General Information
(see reverse for instructions)

Name of Project	Franklin Hills Estates & Country Club	CGP Tracking No.	IR #21-8	Inspection Date	4/16/2021
Inspector Name, Title & Contact Information	Inspector: David McKay, P.E.		Reviewer: David McKay, P.E.		
Present Phase of Construction	Phase 1				
Inspection Location (if multiple inspections are required, specify location where this inspection is being conducted)	Areas of Concern as defined at site walk with wetlands commission.				
<p>Inspection Frequency (Note: you may be subject to different inspection frequencies in different areas of the site. Check all that apply.)</p> <p>Standard Frequency: <input type="checkbox"/> Weekly <input type="checkbox"/> within 24 hours of a 0.5" rain</p> <p>Increased Frequency: <input type="checkbox"/> Every 7 days and within 24 hours of a 0.5" rain (for areas of sites discharging to sediment or nutrient-impaired waters or to waters designated as Tier 2, Tier 2.5, or Tier 3)</p> <p>Reduced Frequency:</p> <ul style="list-style-type: none"> - <input type="checkbox"/> Once per month (for stabilized areas) - <input checked="" type="checkbox"/> Once per month and within 24 hours of a 0.5" rain (for

Photo 1: Stone check dam immediately upgradient of main entry water crossing is in good condition. Some off-road vehicles have started to damage the check dams, but ample capacity is still available.

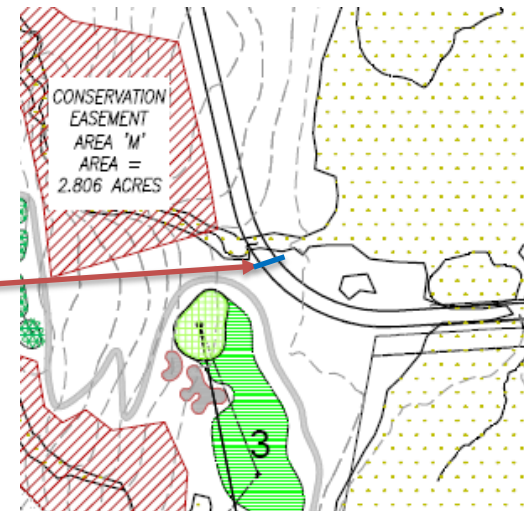
1. Main Entry Water Crossing (Northerly of 3 rd Hole Green)	<input type="checkbox"/> Yes <input checked="" type="checkbox"/> No	<input type="checkbox"/> Yes <input checked="" type="checkbox"/> No		Stone check dam immediately upgradient of crossing has ample storage capacity (Photo 1). Stone check dam in trail leading down to crossing has ample storage capacity (Photo 2). Some off-road vehicles have started to damage the check dams, but ample capacity is still available.

Photo 3: Sediment fence has been repaired and reinforced with stone check dams and is in good condition.

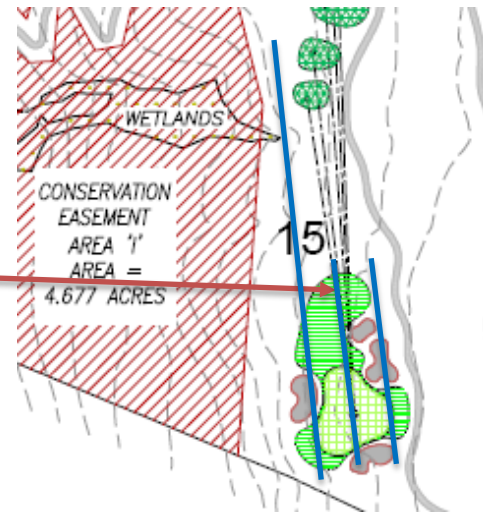
2. 15 th Green Sediment Barriers	<input type="checkbox"/> Yes <input checked="" type="checkbox"/> No	<input type="checkbox"/> Yes <input checked="" type="checkbox"/> No		Downgradient stone check dam remains in good condition. Sediment fence along the cart path and along the tree line are in good condition. Intermediate sediment fence has been re-staked. (Photo 3). Sediment fence rows and staked hay bales in south end have been repaired and eroded area has been stabilized with stone. (Photo 4).

Photo 5: Filtered flow along 15th fairway at stone check dams and perimeter sediment fence.

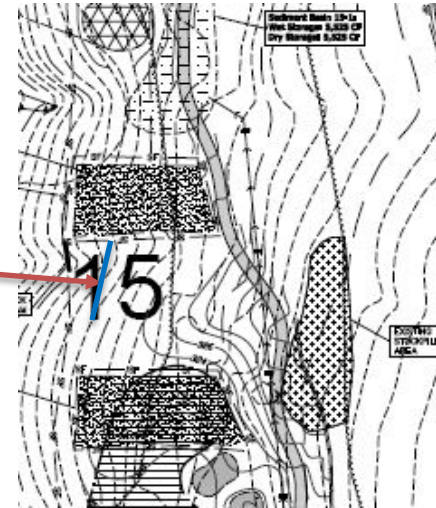
3. 15 th Fairway Sediment Barriers	<input type="checkbox"/> Yes <input checked="" type="checkbox"/> No	<input type="checkbox"/> Yes <input checked="" type="checkbox"/> No		Stone check dams, stone apron are in good condition and functioning as intended. (Photo 5).

3. 15 th Hole Fairway	Plans – Silt fence and stone check dam Existing – Series of stone check dams and silt fence at limits of wooded area to the west	<input checked="" type="checkbox"/> Yes <input type="checkbox"/> No <input type="checkbox"/> N/A	Stone check dams and apron are in good condition and functioning as intended. Clear flow was observed passing through the check dams.

Photo 6: No signs of erosion in swale at entrance driveway.

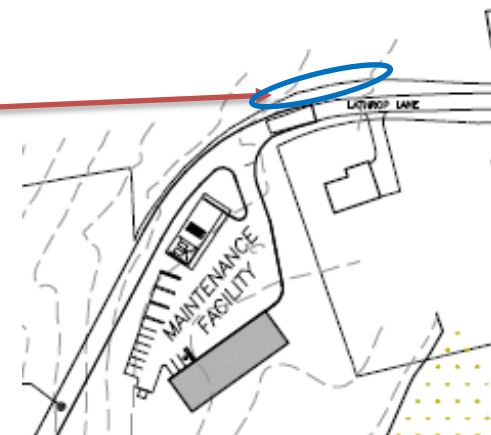
4. Construction Entrance (Westerly of Proposed Maintenance Road)	<input type="checkbox"/> Yes <input checked="" type="checkbox"/> No	<input type="checkbox"/> Yes <input checked="" type="checkbox"/> No		Stone check dam and water bar across construction entrance are in good condition and functioning as intended (Photo 6). Diversion swale excavated to downgradient drainage structure does not show signs of erosion. Stone check dams should be added to new swale if erosion occurs.

Stabilization Area	Stabilization Method	Have You Initiated Stabilization?	Notes
1. Construction Access Drive	Plans - Anti-tracking pad Existing - Water bar at site entrance	<input checked="" type="checkbox"/> Yes <input type="checkbox"/> No <input type="checkbox"/> N/A	There was standing water in the swale during the inspection with no evidence of erosion. Add stone check dams to swale if erosion occurs.

Photo 7: Stone check dams across the 7th hole fairway hillside are in good condition, filtered flow observed.

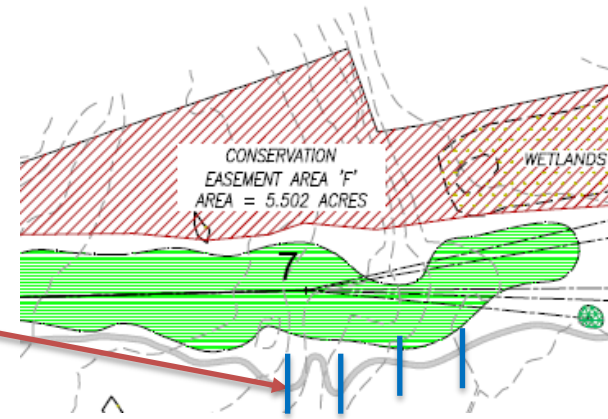
5. 7 th Hole Fairway Hillside	<input type="checkbox"/> Yes <input checked="" type="checkbox"/> No	<input type="checkbox"/> Yes <input checked="" type="checkbox"/> No		Check dams across 7 th Hole fairway are in good condition overall and functioning as intended (Photo 7). Clear flow was observed passing through the check dams.

2. 7 th Hole Fairway Hillside	Plans – Multiple rows of silt fence Existing – Series of stone check dams and silt fence	<input checked="" type="checkbox"/> Yes <input type="checkbox"/> No <input type="checkbox"/> N/A	Area is stabilized at this time. Stone check dams are in good condition and are functioning as intended. Clear flow was observed passing through the check dams.

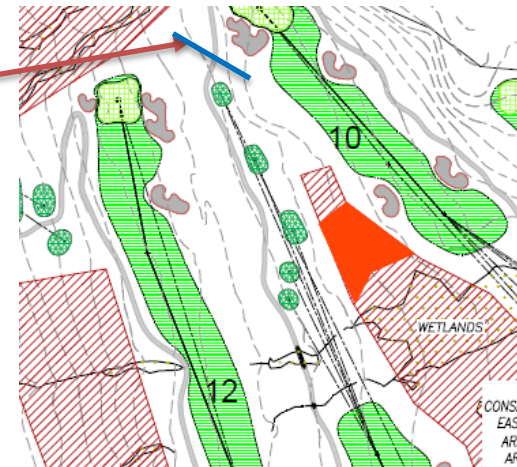
6. 11 th Hole Tee Box Area	<input type="checkbox"/> Yes <input checked="" type="checkbox"/> No	<input type="checkbox"/> Yes <input checked="" type="checkbox"/> No		Sediment fence row across path by 11 th Hole tee box and hay bale check dam are in good condition (Photo 8). Stone check dam has ample storage capacity. Some off-road vehicles have started to damage the hay bales, but ample capacity is still available.

4. 11 th Hole Tee Box Area	Plans – Silt fence and diversion channel Existing – Single row of silt fence across path and one stone check dam	<input checked="" type="checkbox"/> Yes <input type="checkbox"/> No <input type="checkbox"/> N/A	Sediment fence, hay bale check dam and stone check dam are in good condition. Some off-road vehicles have started to damage the hay bales, but ample capacity is still available.

Photo 9: Sediment fence has been repaired and additional stone check dams added to disrupt flows. Measures are in good condition and flow is filtered by stone check dams.

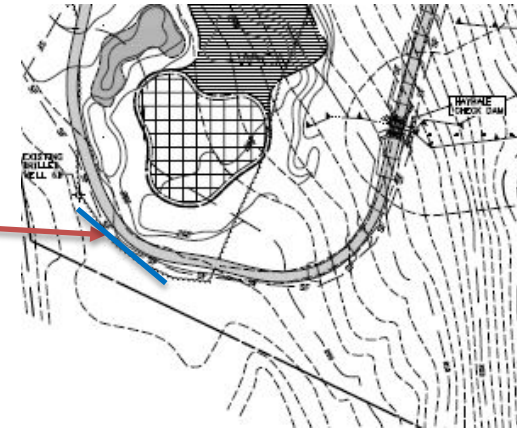
7. 14 th Hole Green Sediment Barriers	<input type="checkbox"/> Yes <input checked="" type="checkbox"/> No	<input type="checkbox"/> Yes <input checked="" type="checkbox"/> No		Additional stone check dams and sediment fence are in good condition (Photo 9).

Photo 10: Clear flow from wetlands outlet.

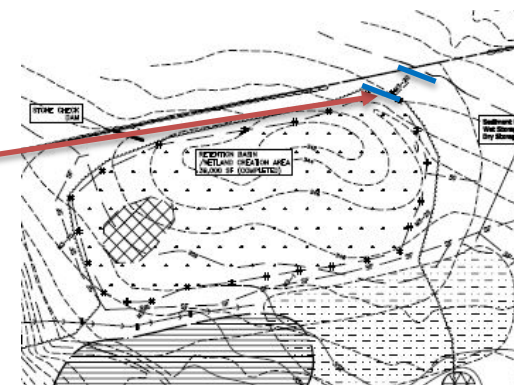
8. Created Wetlands Outlet	<input type="checkbox"/> Yes <input checked="" type="checkbox"/> No	<input type="checkbox"/> Yes <input checked="" type="checkbox"/> No		No repairs required. Discharge from wetlands was flowing clear (Photo 10).
